Job Title		
Cocking Road Thanington		
Drawing Title		
Reserved Masters Spine Road Refuse Vehicle Tracking		
Client		
Redrow Homes		
Scale	Date	Designed
1:1000 @A0	Jan 21	TGL
Drawn	Checked	Approved
TGL	GAC	GAC
Job No	Drawing No	Rev
18-058	18-058-135	-

## Appendix B Correspondence

**From:** Tafari Lewis  
**Sent:** 16 October 2020 09:45  
**To:** matthew.bembridge@kent.gov.uk  
**Subject:** FW: Land North of Cockerling Road, Thanington - CA/20/01777  
**Attachments:** KCC\_HIGHWAYS-2938356.pdf; Cockerling Road, Thanington; RE: Cockerling Road, Thanington

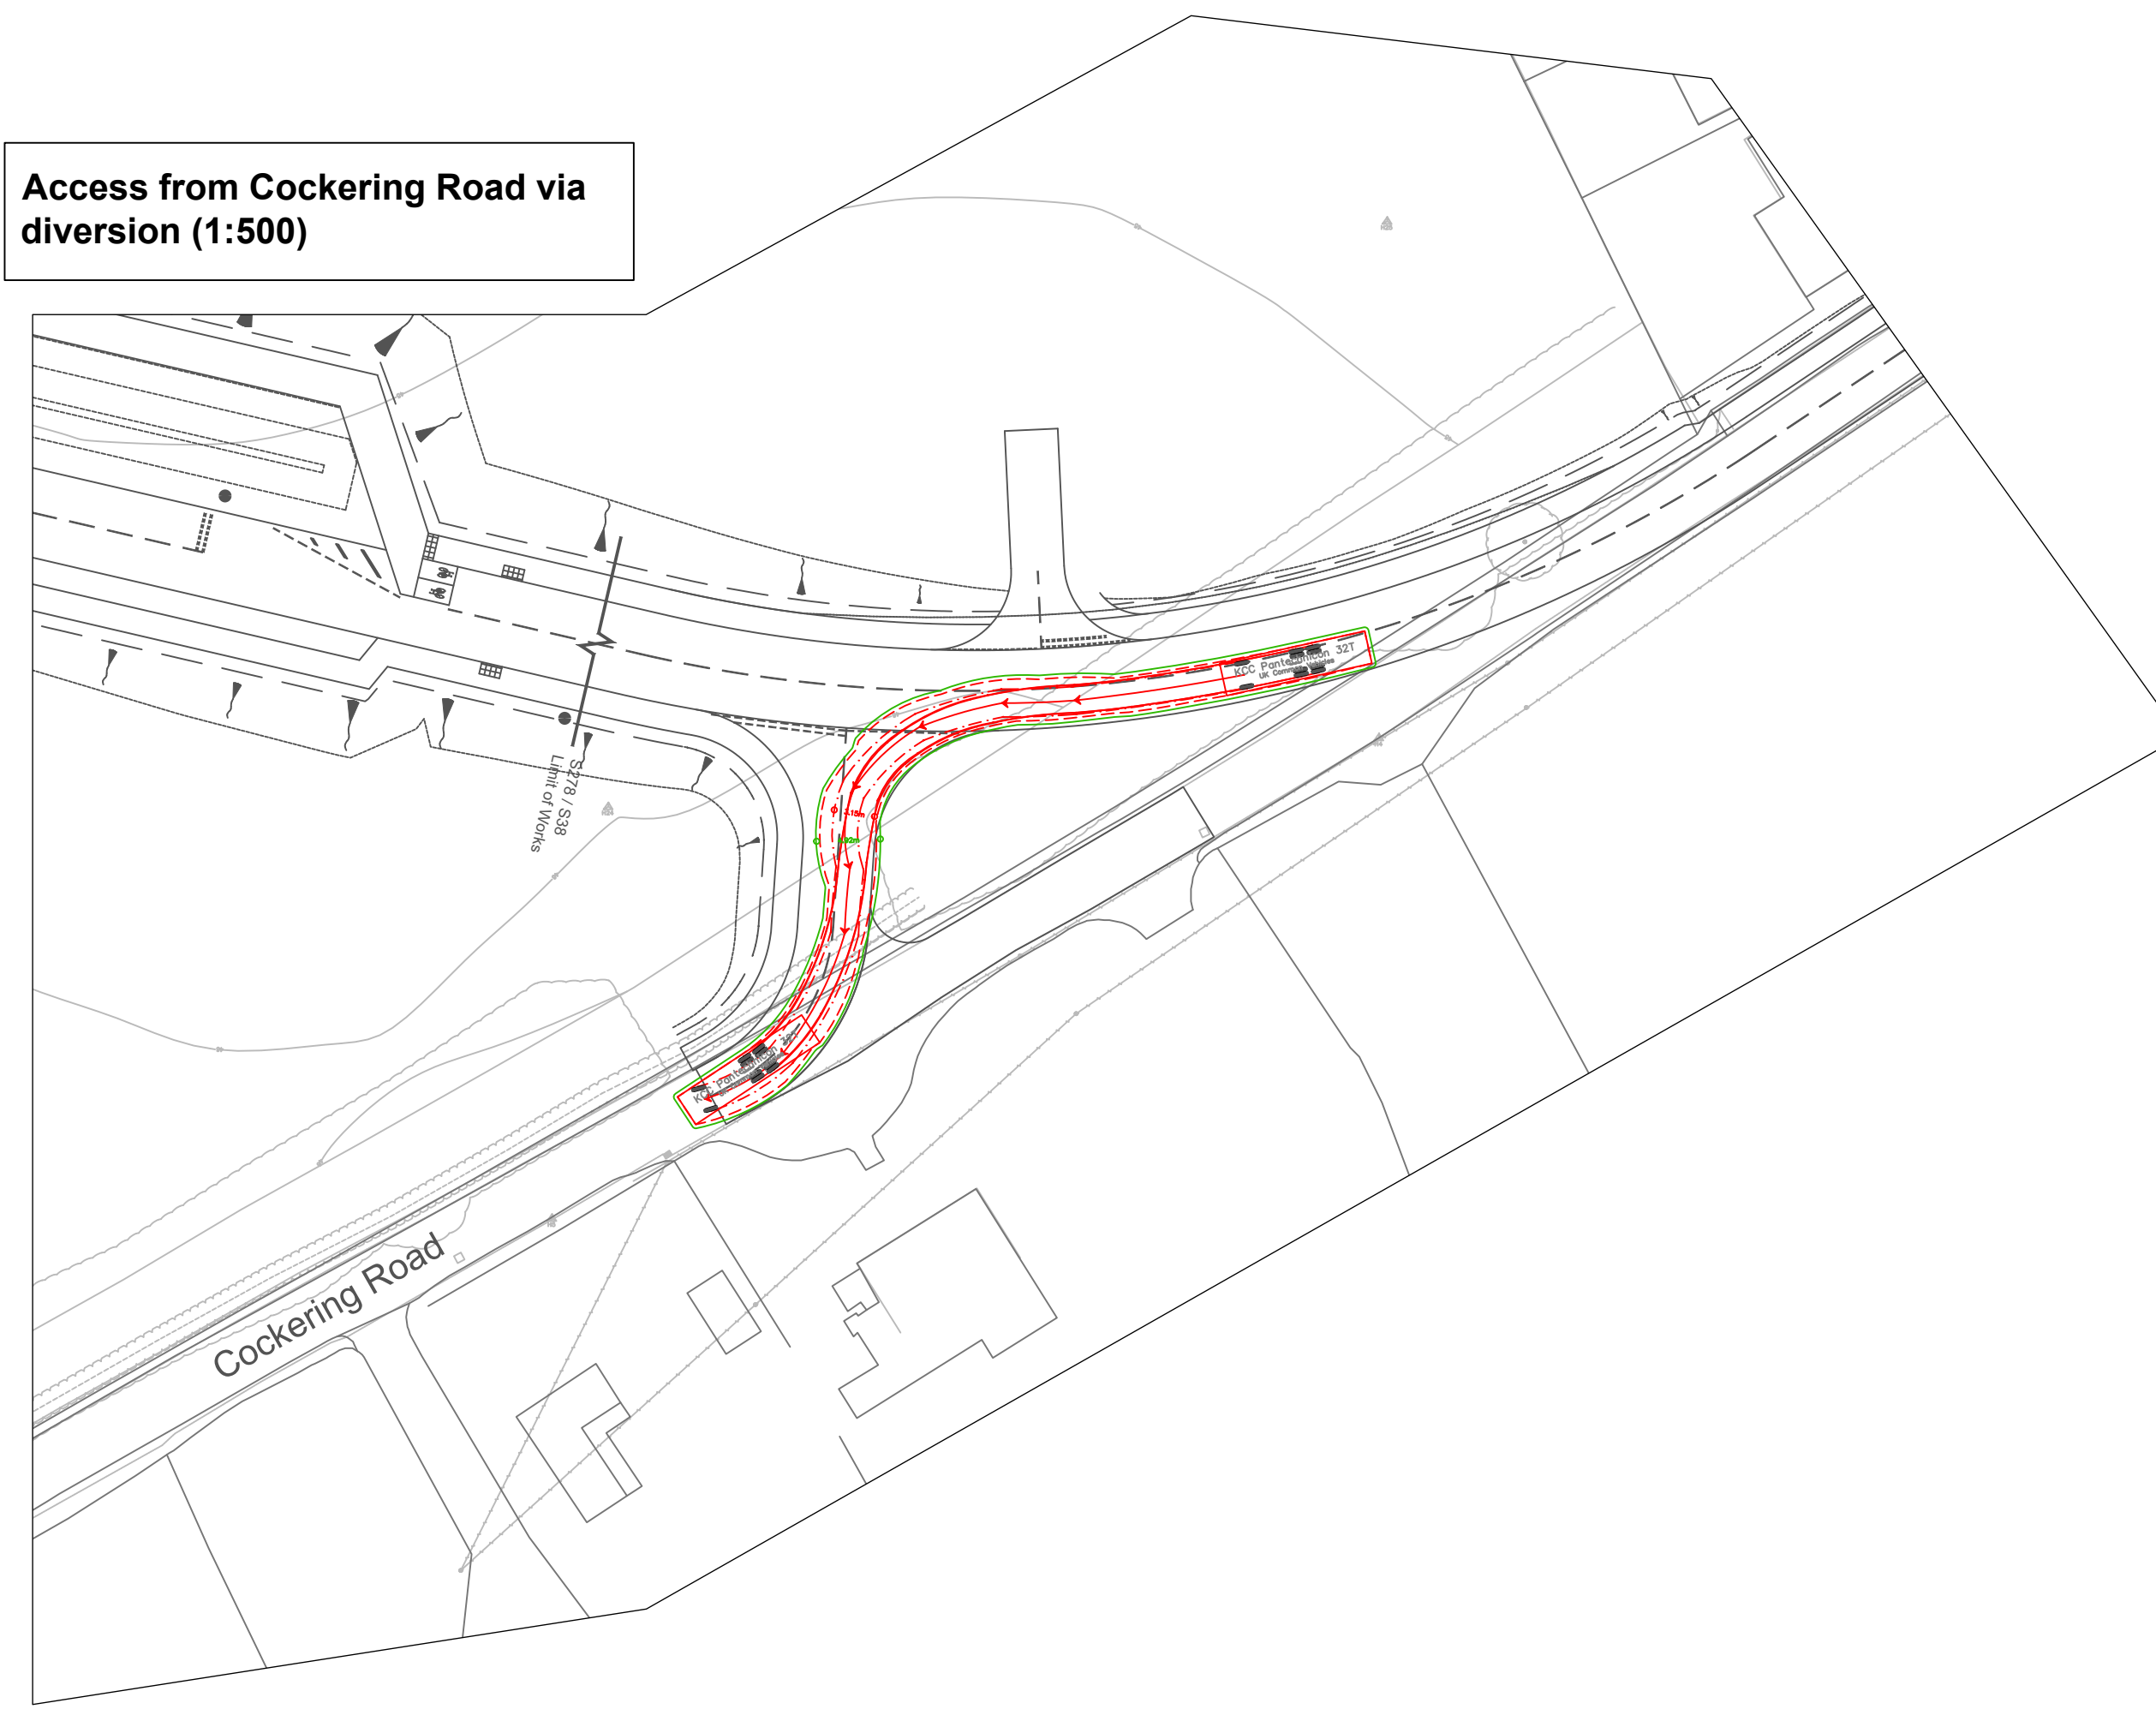
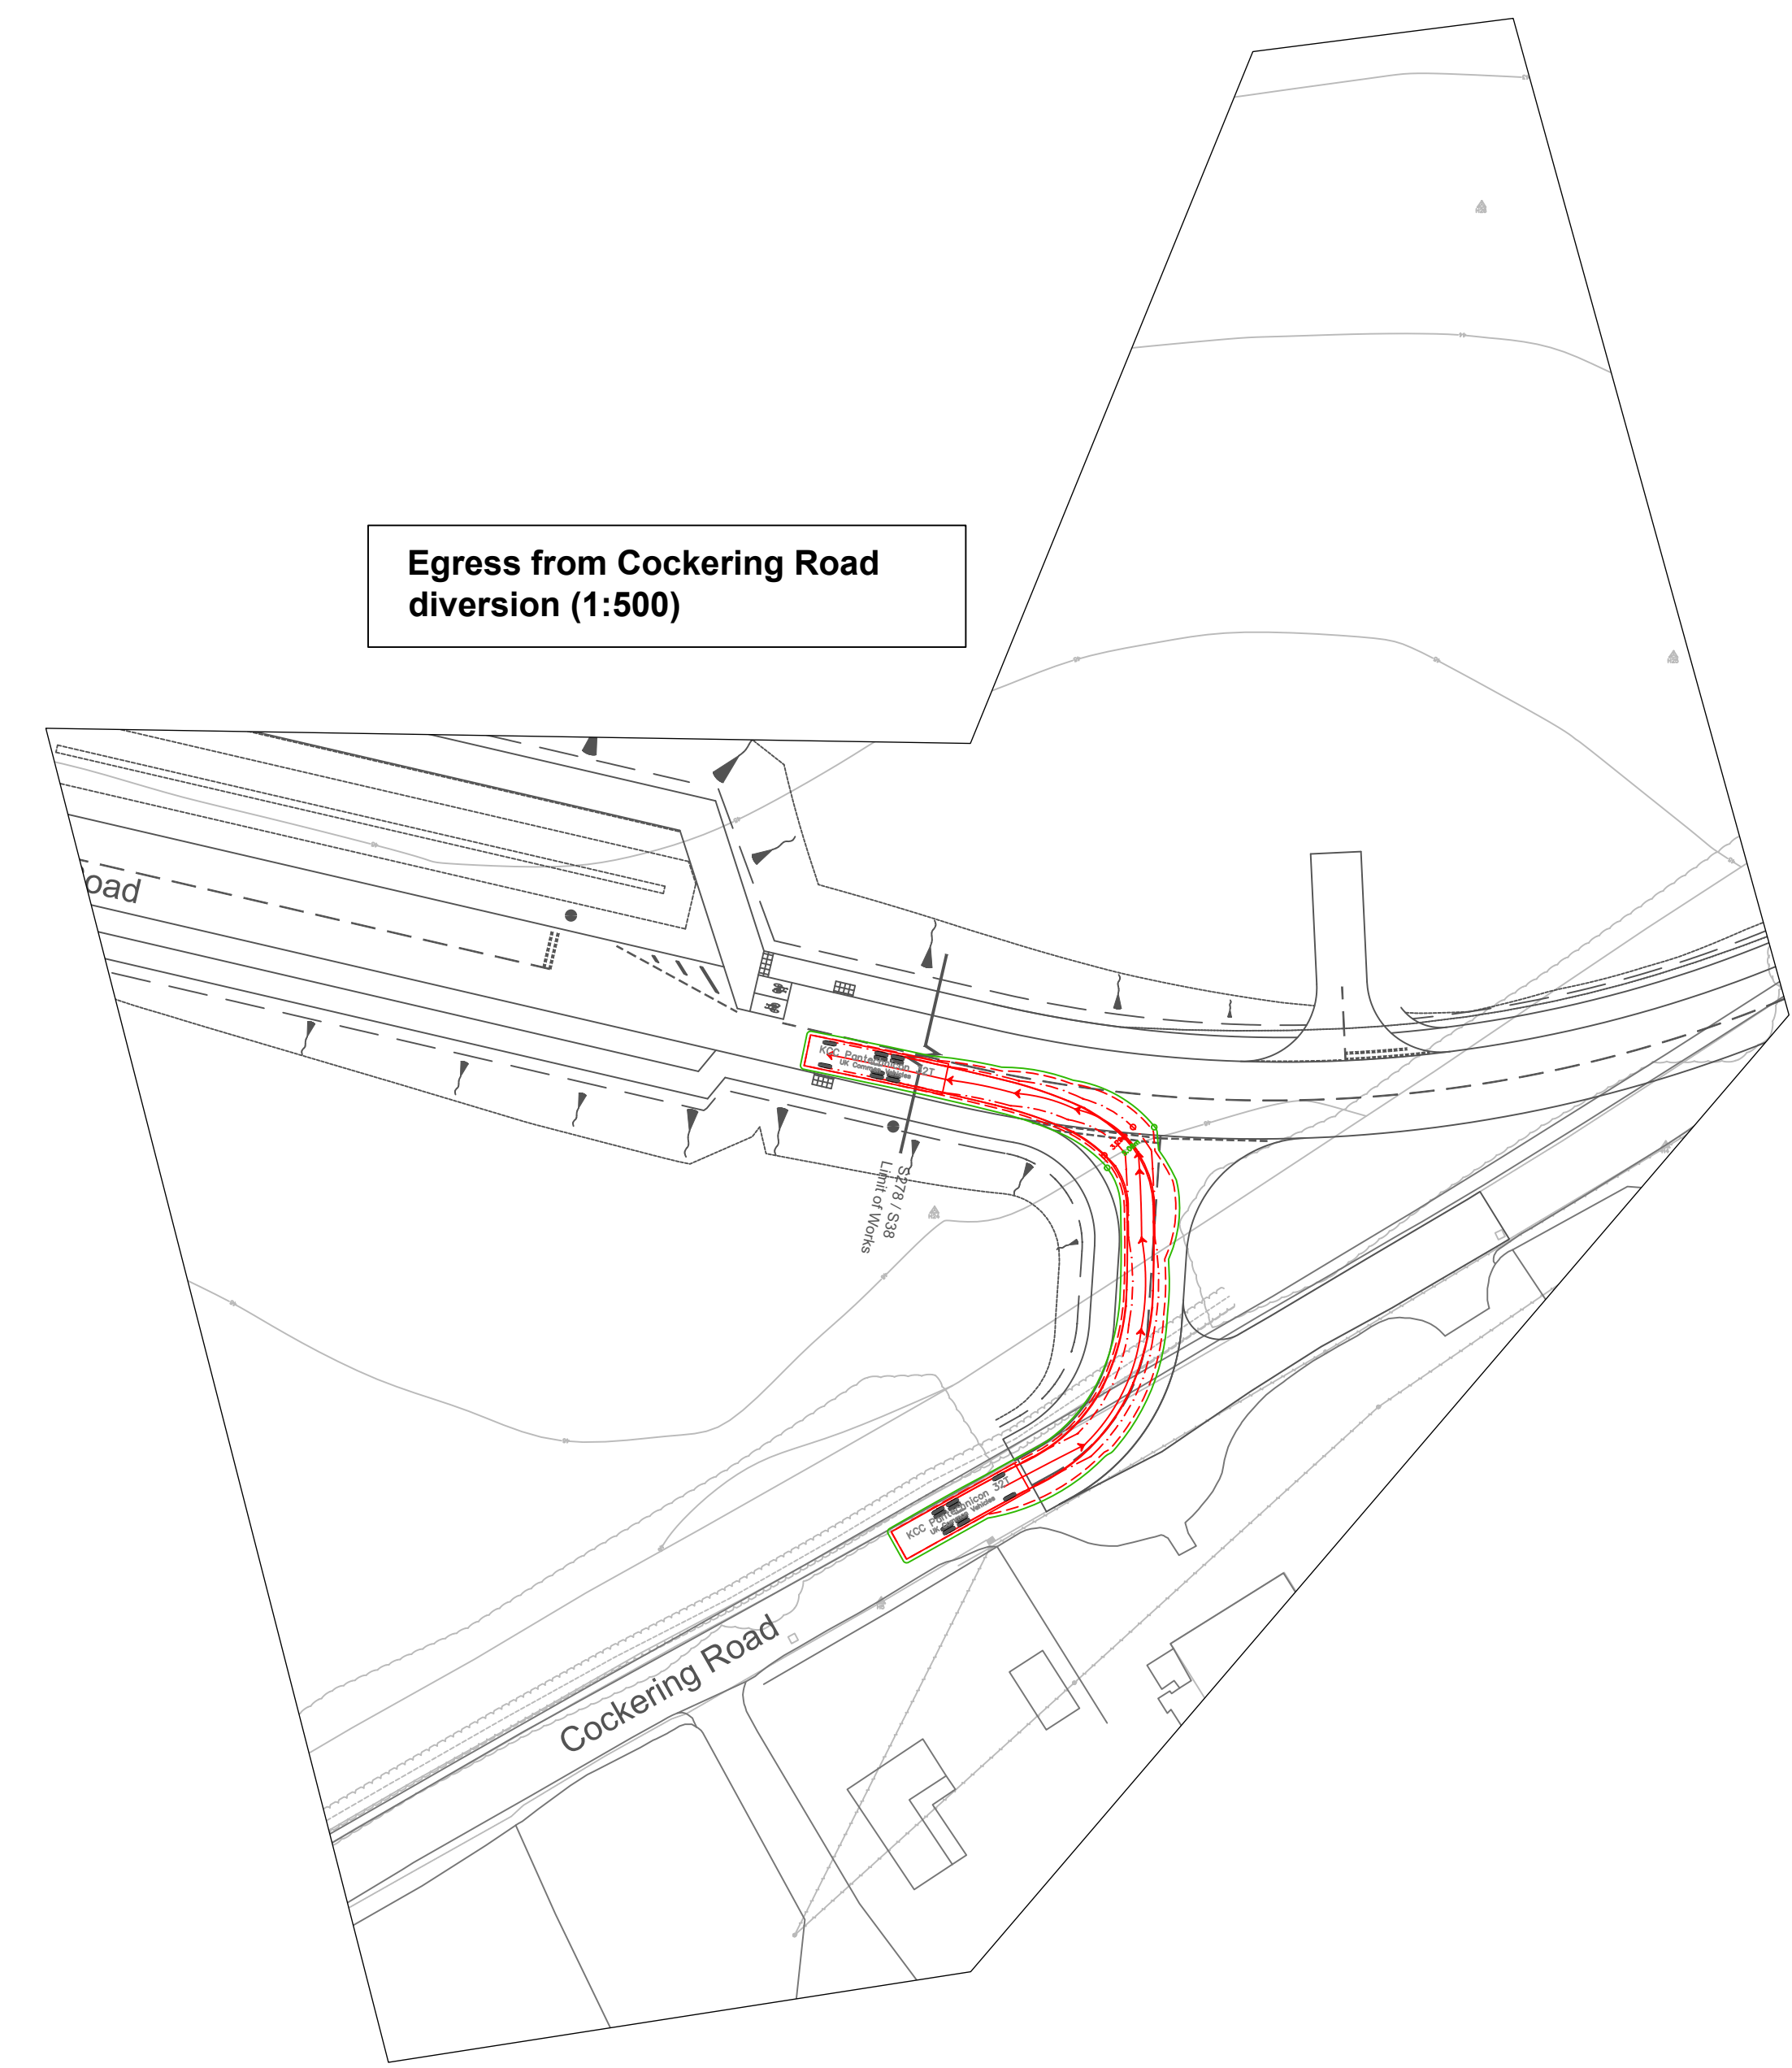
Finally, as discussed one of the comments which came back on the stage 1 audit suggested that the kerb radii on the junction of Cockerling Road (diversion) be increased to avoid the Pantechicon crossing the centreline. In this regard, we've already introduced a kerb radii at 10.5m which we believe is adequate and given the priority arrangements for the traffic calming do not see this as being a major issue.

Thank you for the emails. Could you reproduce the tracking plans for me as I'm afraid I am struggling with the clarity of those submitted.

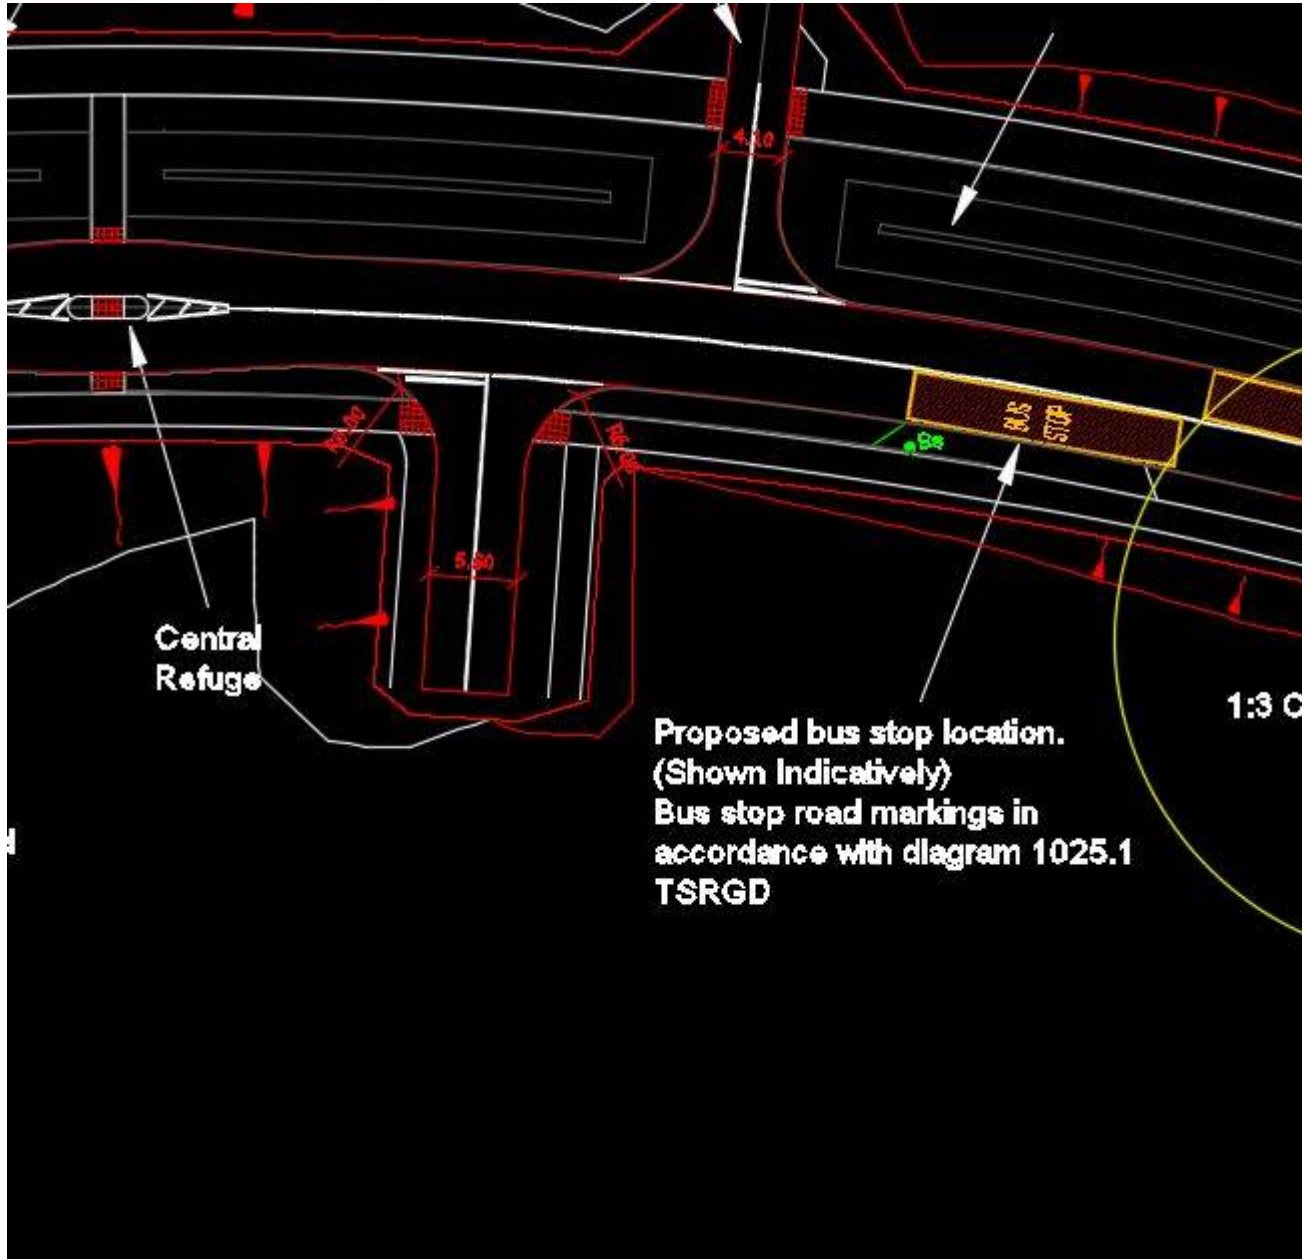
- **Between the last pedestrian island and the last build out.** We are currently reviewing this and given the density of junctions and the bus stops between these locations are finding it difficult to provide a suitable point to introduce a buildout without providing a vertical traffic calming feature instead. Colin was quite clear in our initial discussions to avoid the use of traffic calming measures on the LDR that included speed humps or other forms of vertical deflection. Below is a screenshot of the suggested position for the buildout.

I've repositioned the westbound bus stop to reflect your recommended 'tail to tail' arrangement meaning that the only logical position is to introduce the speed restraint is just before this location. We need to account for refuse vehicles exiting the eastern junction which means that the buildout is located immediately adjacent the eastbound bus stop location. I've measured the distance between the eastern advance warning sign buildout and the central refuge taper to the west which measures approximately 162m. In this instance would it be ok to relax the distances based upon the above criteria or would you prefer we introduce the speed restraint measure as per the screenshot above.
